R22 SERVICE LETTER SL-92

R44 SERVICE LETTER SL-81

R66 SERVICE LETTER SL-39

SUBJECT: ELT Security

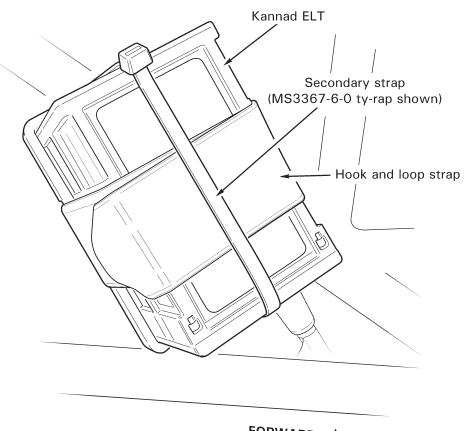
During periodic inspections, maintenance personnel should verify the ELT is properly seated in the mounting bracket and the hook & loop strap has no slack or deterioration.

The hook & loop strap and mounting bracket may deteriorate over time and should be replaced if damage is noted, or every 12 years, whichever occurs first. A Kannad P/N S1840502-01 kit (available from RHC Customer Service) includes a mounting bracket and hook & loop strap.

Ensure a secondary strap is installed. Acceptable secondary straps are:

B359-2 Releasable ty-rap (installed at RHC factory circa 2008 – 2011)

D693-4 Strap (installed at RHC factory circa 2011 – 2021)

MS3367-6-0 Ty-rap (current production)

Early R22 and R44 Kannad ELT installations did not include a secondary strap and should be upgraded. Refer to figure on page 2.
